Service Bulletin

Subject: Information on Ordering New Delphi Style Fuel Pump

Brand:	Model:	Model Year:		VIN:		Engine:	Transmission:
		from	to	from	to		
Chevrolet	Silverado	2016	2016			5.3L Engine (RPO L83)	8 Speed Transmission (RPO M5U)
GMC	Sierra	2016	2016			5.3L Engine (RPO L83)	8 Speed Transmission (RPO M5U)

Stanadyne style fuel pump part number 12669519 and fuel pipe part number 12673077 as shown above.

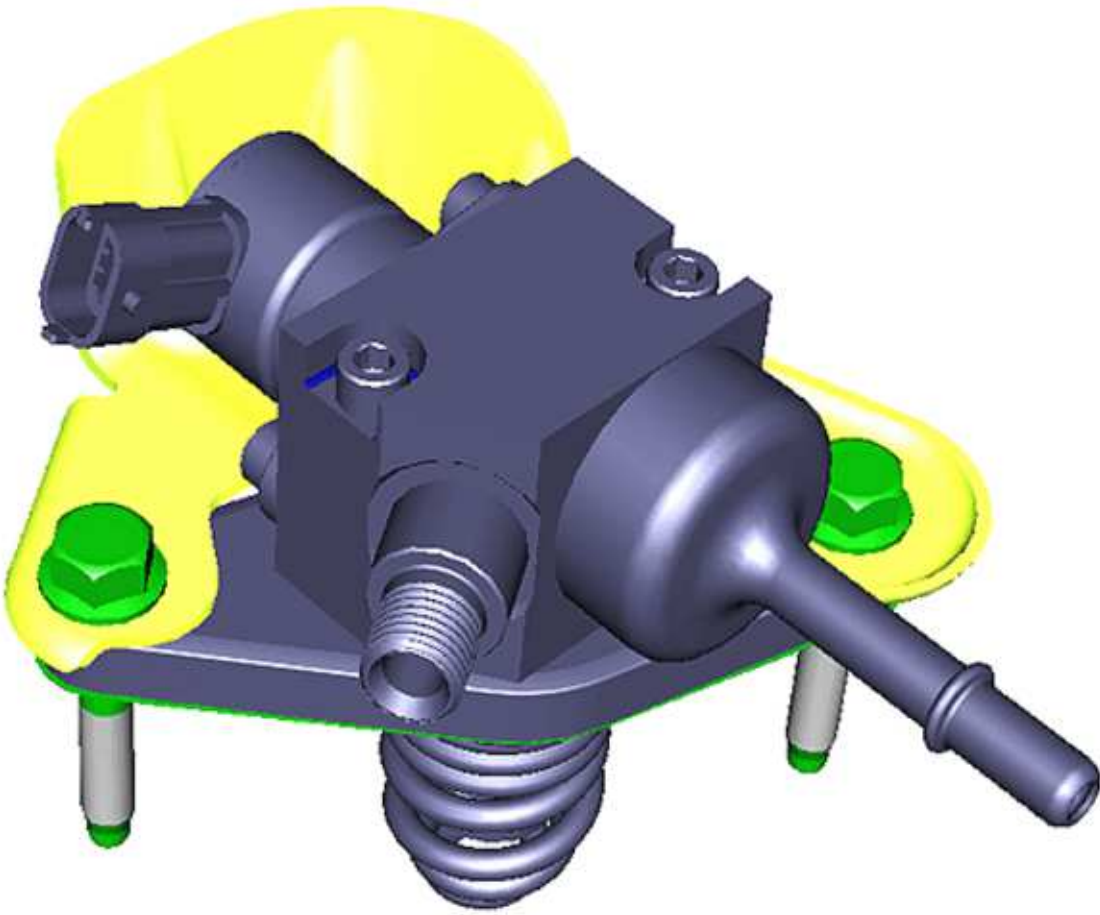
The purpose of this Bulletin is to inform dealership personnel that when replacing the fuel pump, the vehicle should be serviced with the same style high pressure fuel pipe and SIDI fuel pump it was equipped with for the following reasons:

Note: A note will be added in the Parts Catalog to ensure that the technician orders and replaces the fuel pump with the correct part number and style.
